**SELF-STORAGE DEVELOPMENT & BUILDING ADDITION**

TAX MAP PARCEL 7-25 - 19 PERRY ROAD

MILFORD, NEW HAMPSHIRE

**Subject:** William T. Mahar, Tax Map 7 Lot 25, 19 Perry Road. Conditional Use Permit Application pursuant to Section 7.13 of the Zoning Ordinance and Major Site Plan Application to construct three (3) self-storage buildings totaling 9,500 sf and a 1,800 square foot building addition, and related parking, landscaping, and drainage improvements within the Integrated Commercial – Industrial 2 Zoning District and the Commerce Community Overlay District. In addition, Conditional Use Permit application pursuant to Section 6.06.6.F seeking relief from Section 6.06.6 Administration the administrative process and application requirements for submitting a Master Regulating Plan.

**EXISTING CONDITIONS PLAN**  
**TAX MAP PARCEL 7-25 - 19 PERRY ROAD**  
**MILFORD, NEW HAMPSHIRE**  
 PREPARED FOR AND LAND OF:  
**WILLIAM T. MAHAR**  
 19 PERRY ROAD, MILFORD, NH 03055-4308

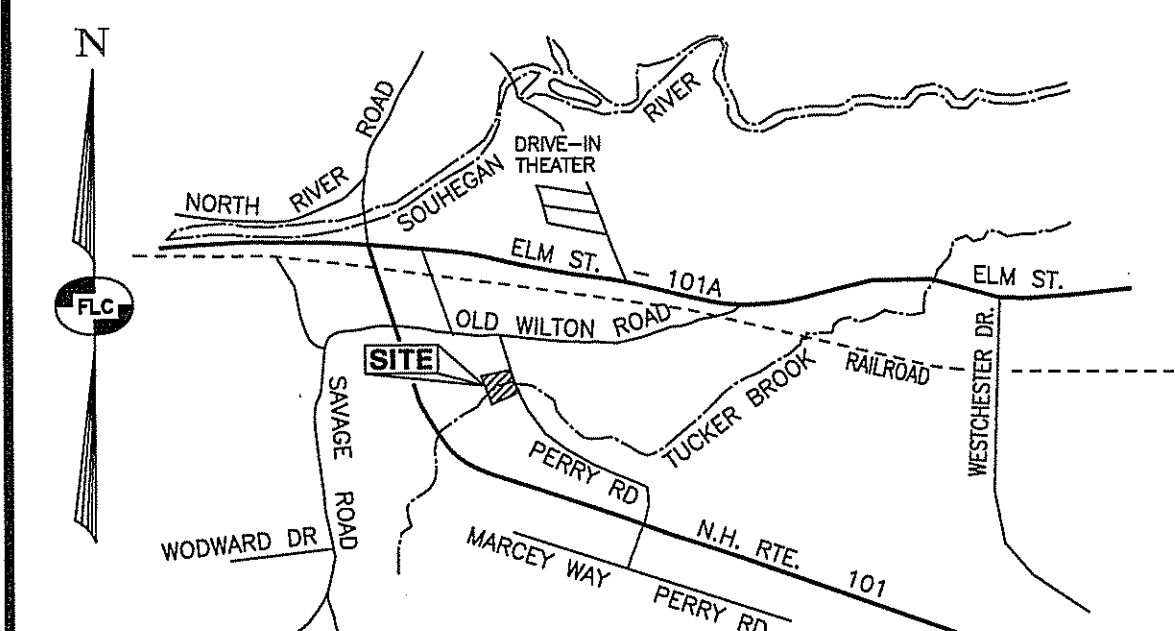
1. Sheet 2, Wetland Buffer. Please revise the plan to show the correct 50' wetland buffer from Tucker Brook to consistent plan notes and following sheets. The plan currently shows a 25' delineated buffer. **Addressed**

2. Sheet 2, Wetland Buffer. Please revise the plan to show the correct 50' wetland buffer from Tucker Brook to consistent plan notes and following sheets. The plan currently shows a 25' delineated buffer. **The plan has been revised as requested.**

**SITE PLAN**  
**TAX MAP PARCEL 7-25 - 19 PERRY ROAD**  
**MILFORD, NEW HAMPSHIRE**  
 PREPARED FOR AND LAND OF:  
**WILLIAM T. MAHAR**  
 19 PERRY ROAD, MILFORD, NH 03055-4308

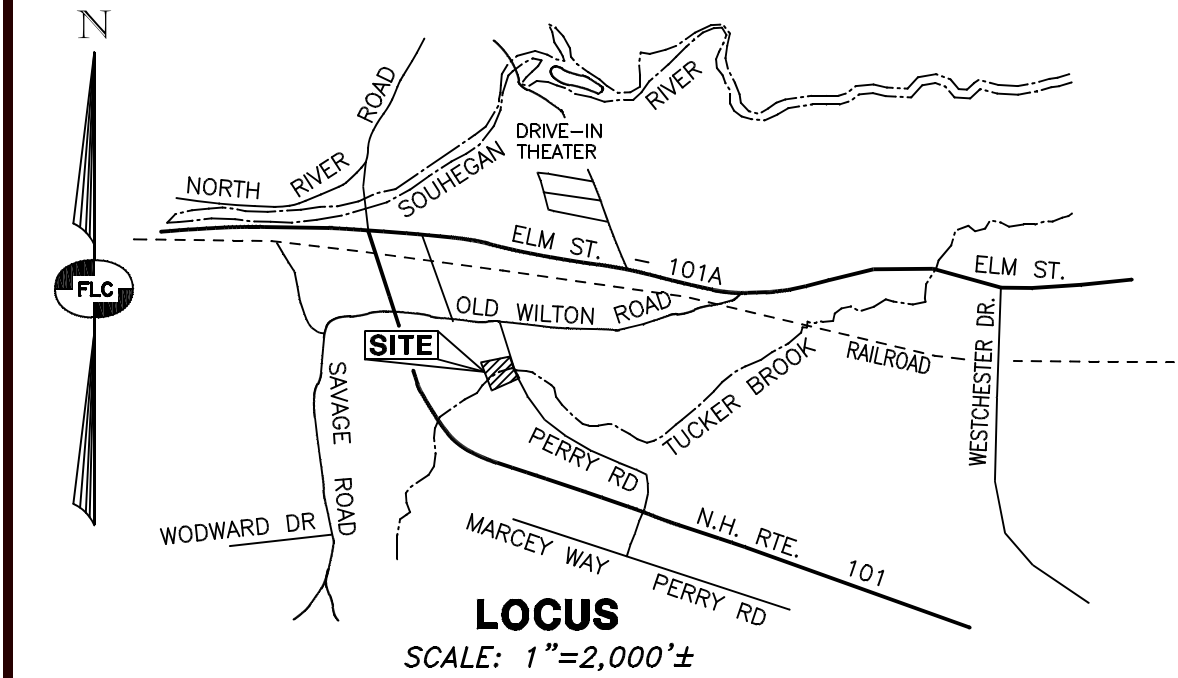
3. Sheet 3, Parking Spaces. Please revise the plan to include a table stating the number of existing and proposed parking spaces. Please revise the plan to show the parking areas for employees, customers, and customer vehicles associated with the garage operation and addition. **Partially Addressed. Please add a note or table to the plan detailing the parking calculation/analysis.**

4. Sheet 3, Parking Spaces. Please clarify if there will be any outside storage of vehicles, boats, RVs associated with the storage facility? If yes, please update the plan accordingly. **Partially Addressed. Please clarify if the proposal calls for the outside storage of vehicles, boats, and RVs. If yes, please update the plan accordingly.**

5. Sheet 3, Designated Snow Storage Areas. A large snow storage area is located within the 50 foot wetland buffer to Tucker Brook and over the proposed detention basin. Please explain the rationale for locating snow storage areas within the buffer zone and what alternatives were considered. The primary concern is the use of chlorides and other deicing agents to manage the impervious surface around the site and long-term impact to Tucker Brook. **Partially Addressed. Recommend that a note be added to the plan stating that no salt shall be used to manage the impervious surface associated with the vehicle repair operation and self-storage facilities.**

6. Sheet 3, Proposed Snow Management Plan. Given the proximity of the project to the Tucker Brook, please discuss the proposed snow maintenance and management plan. **Partially Addressed. See previous comment.**

4. Sheet 3, Parking Spaces. Please revise the plan to include a table stating the number of existing and proposed parking spaces. Please revise the plan to show the parking areas for employees, customers, and customer vehicles associated with the garage operation and addition. **This has been added to the plans as requested.**

5. Sheet 3, Parking Spaces. Please clarify if there will be any outside storage of vehicles, boats, RVs associated with the storage facility? If yes, please update the plan accordingly. **The outdoor storage of vehicles has been addressed in Note #2 on Sheet 3. There is no long term plans for outdoor storage once the site construction is completed.**

6. Sheet 3, Designated Snow Storage Areas. A large snow storage area is located within the 50 foot wetland buffer to Tucker Brook and over the proposed detention basin. Please explain the rationale for locating snow storage areas within the buffer zone and what alternatives were considered. The primary concern is the use of chlorides and other deicing agents to manage the impervious surface around the site and long-term impact to Tucker Brook. **This plan really consists of restoring the buffer area. All of the existing disturbances of the buffer area, in the project area, will be removed and the area will be restored through the construction of our infiltration basin. This basin has been designed to handle extreme precipitation storm events and any snow melt will make its way into this basin and be infiltrated and treated through the soils. There will be no direct discharges into the adjacent jurisdictional area. Currently there is no stormwater mitigation on-site so all snow would melt and run into the wetlands. Given this we believe this design will be an improvement over the existing conditions. Also self storage sites are very low volume facilities so ice treatment is less critical and is most often treated with the application of sand.**

7. Sheet 3, Proposed Snow Management Plan. Given the proximity of the project to the Tucker Brook, please discuss the proposed snow maintenance and management plan. **The owner plans to handle the snow maintenance and management himself which would consist of plowing the site as needed and applying sand to the surface as needed. Salt use would**

**GRADING & UTILITY PLAN**  
**TAX MAP PARCEL 7-25 - 19 PERRY ROAD**  
**MILFORD, NEW HAMPSHIRE**  
 PREPARED FOR AND LAND OF:  
**WILLIAM T. MAHAR**  
 19 PERRY ROAD, MILFORD, NH 03055-4308

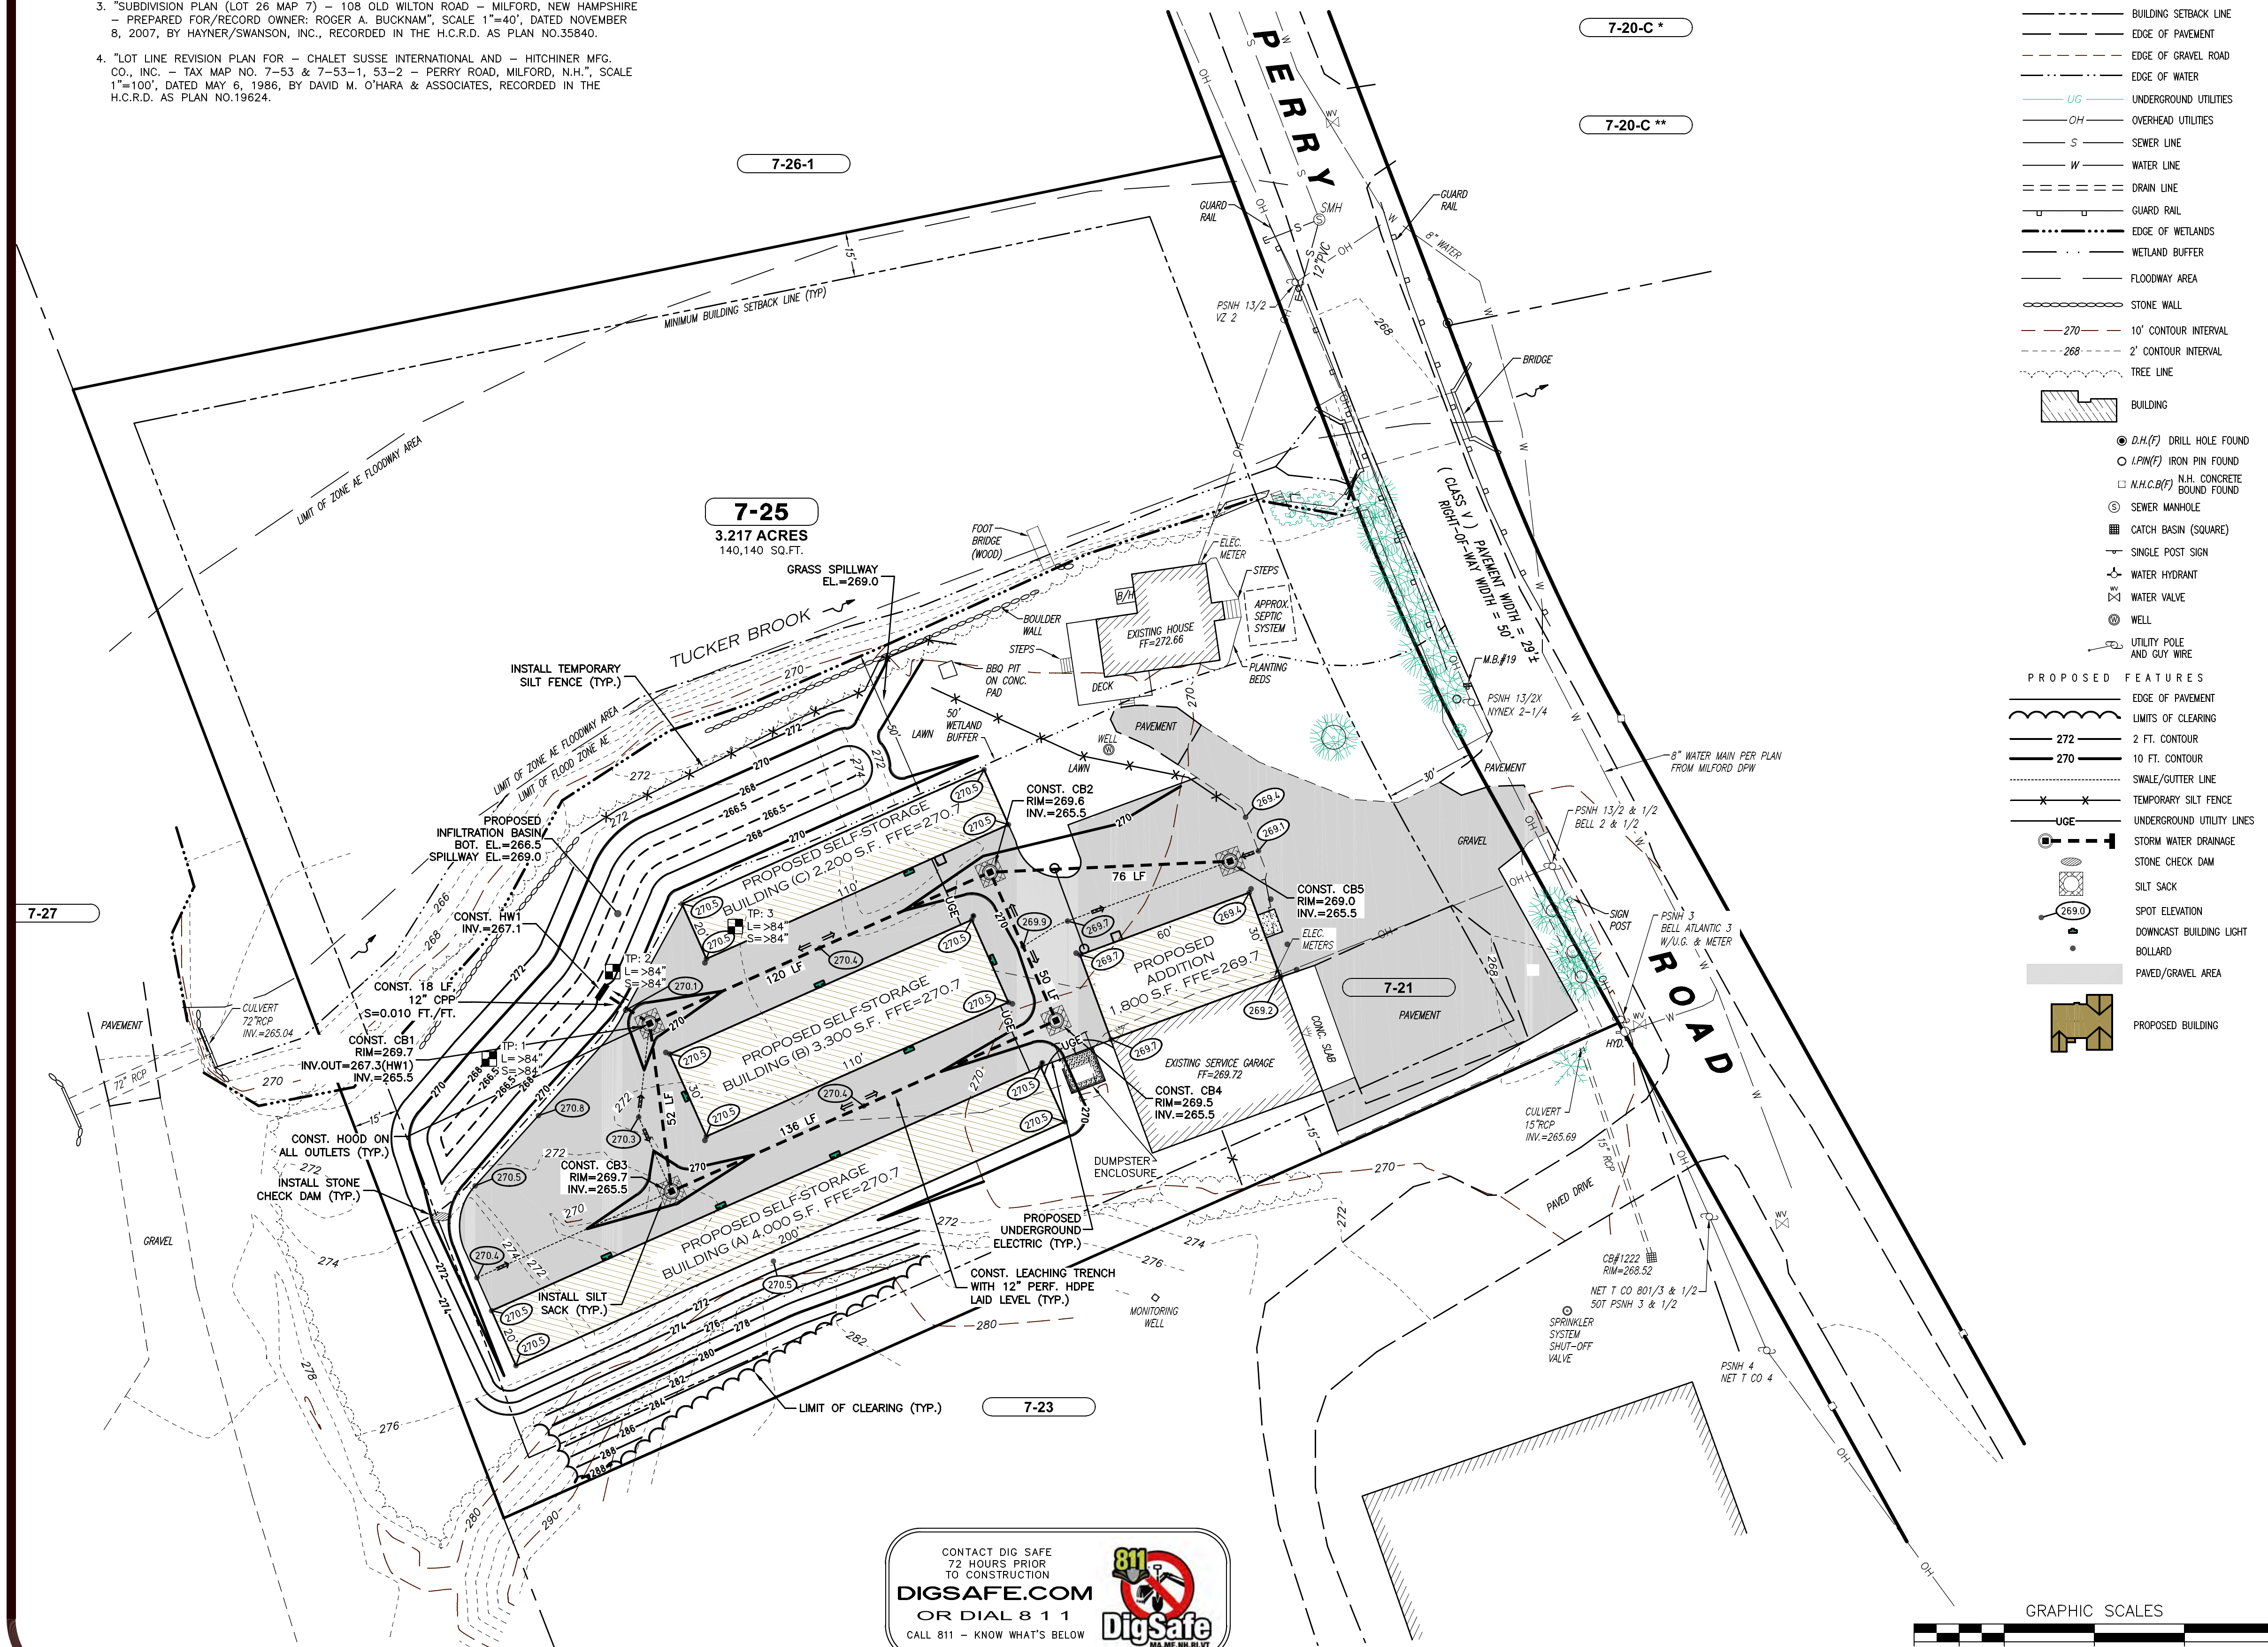
7. Sheet 4, Proposed Drainage Basin. The drainage basin is located within the 50 foot wetland buffer from Tucker Brook. In accordance with Section 6.02.6.B of the Milford Zoning Ordinance, the use would require a Special Exception from the Board of Adjustment. The drainage basin is not a listed permitted use in Section 6.02.5 Accepted Uses, B. Buffer Zones.

10. Sheets 4 and 5, Detention Basin. Please revise the plan to show the engineering and construction details for the detention basin. Currently, no detail is provided. Please explain why the detention basin could not be designed as a fully function rain garden complete with plantings? Given its current proposed location within the 50' wetland buffer to Tucker Brook, the applicant should make every effort to improve stormwater management/water quality and mitigate impacts to Tucker Brook. **Addressed.**

8. Sheet 4, Proposed Drainage Basin. The drainage basin is located within the 50 foot wetland buffer from Tucker Brook. In accordance with Section 6.02.6.B of the Milford Zoning Ordinance, the use would require a Special Exception from the Board of Adjustment. The drainage basin is not a listed permitted use in Section 6.02.5 Accepted Uses, B. Buffer Zones. **As discussed this project does not propose an additional impacts to the wetlands buffer area. In fact this project is really proposes to restore the existing historical impacts to the buffer area. This will included the removal of structures, materials, storage, etc. in these areas and the restoration of this buffer area through the construction of a vegetated infiltration basin, loaming and seeding and landscaping the area as depicted on the attached plan set. When you consider this the project will actually make the site more compliant.**

10. Sheets 4 and 5, Detention Basin. Please revise the plan to show the engineering and construction details for the detention basin. Currently, no detail is provided. Please explain why the detention basin could not be designed as a fully function rain garden complete with plantings? Given its current proposed location within the 50' wetland buffer to Tucker Brook, the applicant should make every effort to improve stormwater management/water quality and mitigate impacts to Tucker Brook. **The plans have been revised to incorporate the suggested construction details. As previously discussed this plan will restore the buffer areas and all stormwater will be collected and infiltrated through the closed drainage system and proposed infiltration basin. This design will improve stormwater management and quality on-site and will certainly mitigate the proposed development and will not have adverse impacts to Tucker Brook.**

**LANDSCAPING & LIGHTING PLAN**  
**TAX MAP PARCEL 7-25 - 19 PERRY ROAD**  
**MILFORD, NEW HAMPSHIRE**  
PREPARED FOR AND LAND OF:  
**WILLIAM T. MAHAR**  
19 PERRY ROAD, MILFORD, NH 03055-4308

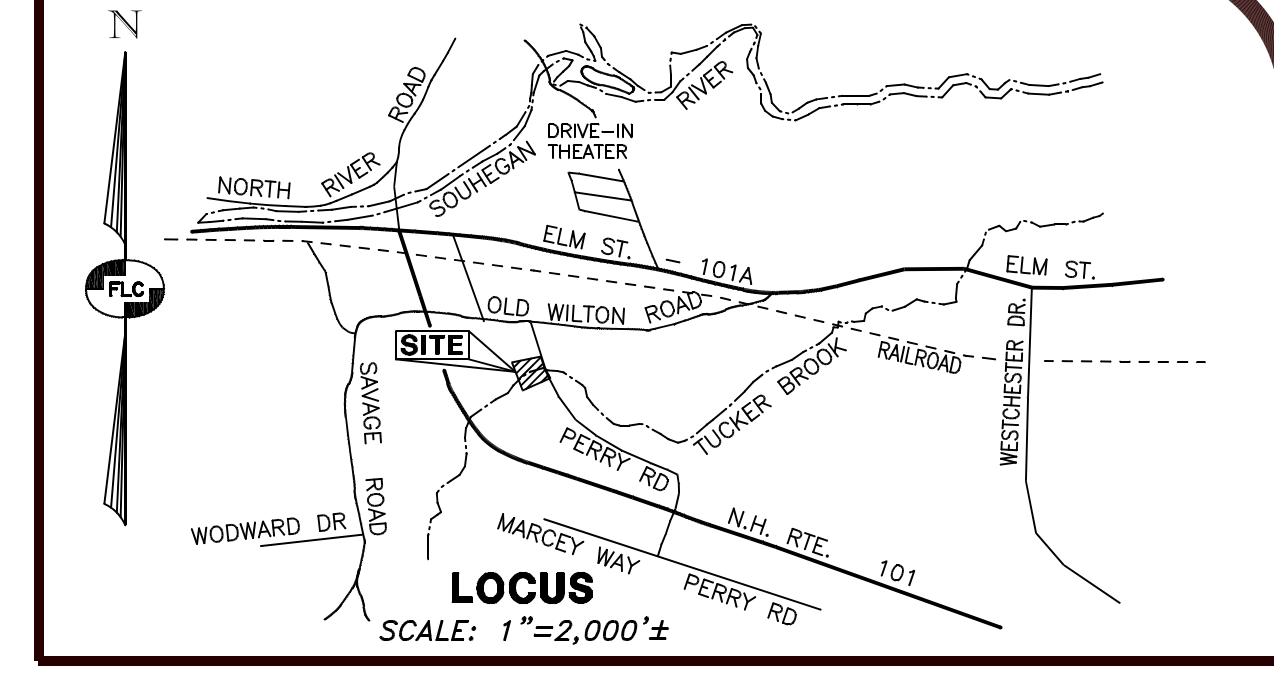
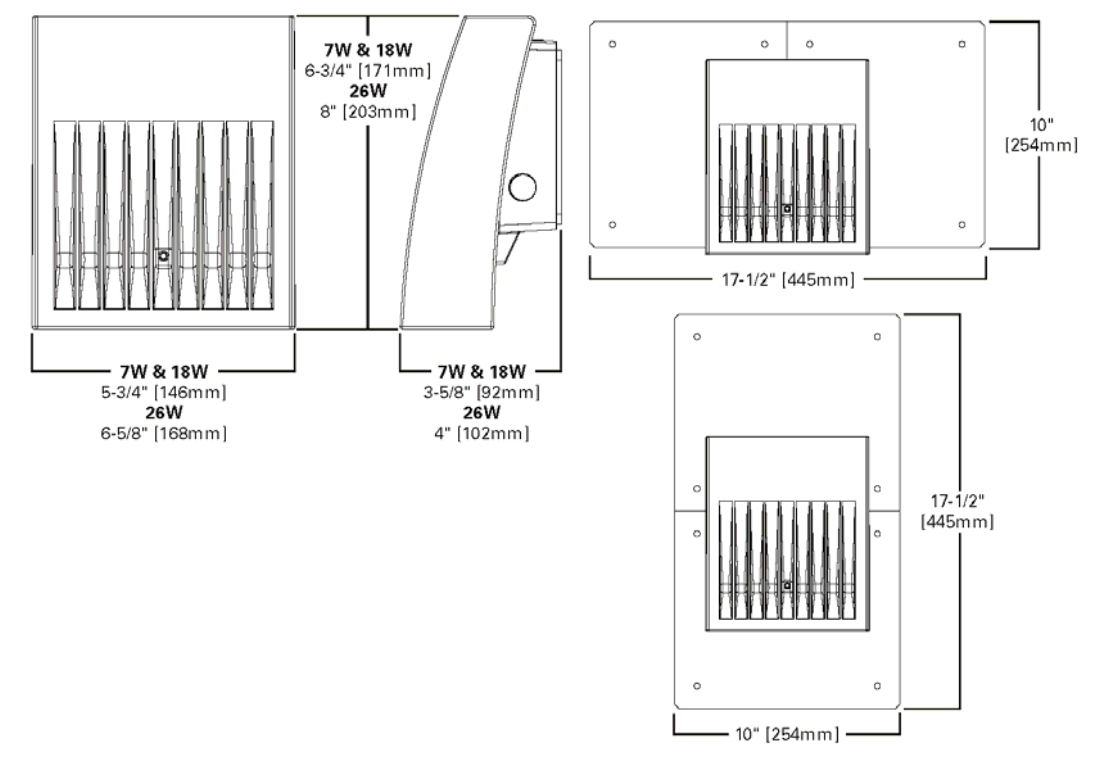
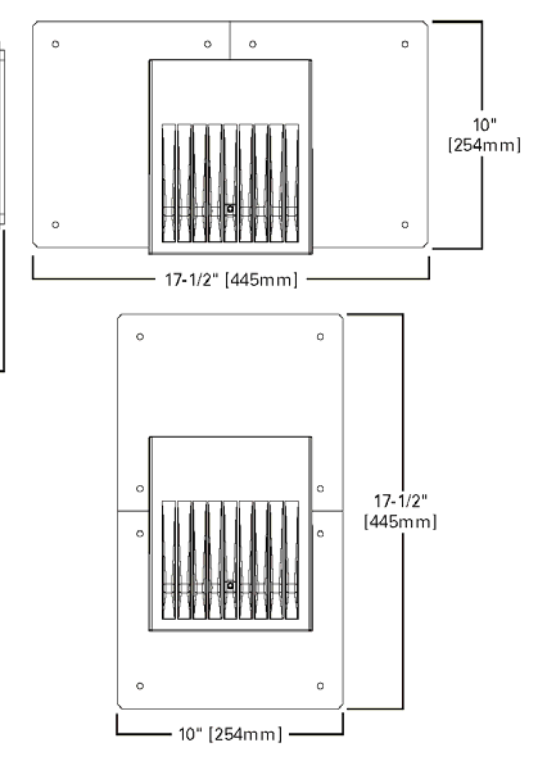
8. Sheet 5, Landscaping and Lighting Plan. It is staff's understanding that project seeks to utilize the existing landscaping along Perry Road to meet the minimum landscape design standards. Please provide a narrative detailing how the existing landscaping design meets Milford Zoning Ordinance, Section 6.06.9 and the Development Regulations or submit a waiver request seeking relief from the minimum standards for landscaping. **Addressed.**

9. Sheet 5, Landscaping and Lighting Plan. No detail is provided to show how the previously disturbed areas within the 50 foot wetland buffer will be restored. Please revise the plan to show the restoration of the previously disturbed areas located north of the proposed Build C and the detention basin. As part of the update, please revise the construction detail sheets to include the planting and maintenance specifications and best management

11. Sheet 5, Landscaping and Lighting Plan. Please revise the plans to include additional visual screening along the south eastern portion the property abutting Lot 7-23. The area is currently lacking visual mitigation. **Addressed.**

12. Sheet 5, Landscaping and Lighting Plan. Please confirm if the front part of the property contains a minimum of a 10' wide landscaped area. **Addressed.**

13. Sheet 5, Landscaping and Lighting Plan. Will the project include a dumpster? If yes, please provide the location and associated engineering, construction details, and landscape design elements on a revised plan. **Addressed. Addressed.**

14. Sheet 5, Landscaping and Lighting Plan. Please revise the plan to include all existing and proposed signage. Please include the associated engineering and construction details. **Addressed.**

9. Sheet 5, Landscaping and Lighting Plan. No detail is provided to show how the previously disturbed areas within the 50 foot wetland buffer will be restored. Please revise the plan to show the restoration of the previously disturbed areas located north of the proposed Build C and the detention basin. As part of the update, please revise the construction detail sheets to include the planting and maintenance specifications and best management practices. Preference should be given to using a wetland seedmix. **The plans have been revised to incorporate restoration and landscaping details. As discussed this plan really is a restoration plan for the buffer areas. Structures, storage of materials, etc. will no longer be located in the buffer area and the area will be graded and re-established with vegetation as depicted on the plans. The appropriate seed mixtures have been selected for the soil conditions.**

11. Sheet 5, Landscaping and Lighting Plan. Please revise the plans to include additional visual screening along the south eastern portion the property abutting Lot 7-23. **The plans have been revised as requested.**

12. Sheet 5, Landscaping and Lighting Plan. Please confirm if the front part of the property contains a minimum of a 10' wide landscaped area. **The front part of the property does contain a minimum of a 10 foot wide landscaped area.**

13. Sheet 5, Landscaping and Lighting Plan. Will the project include a dumpster? If yes, please provide the location and associated engineering, construction, and landscape design elements on a revised plan. **The project is not anticipating the use of a dumpster as noted but we have included a dumpster location to the rear of the existing auto garage in case the owner decides to add one to the site in the future.**

14. Sheet 5, Landscaping and Lighting Plan. Please revise the plan to include all existing and proposed signage. Please include the associated engineering and construction details. **The site plan and details incorporate any proposed signage. The sign for the site is currently a building mounted wall sign so there are no free standing signs on-site.**
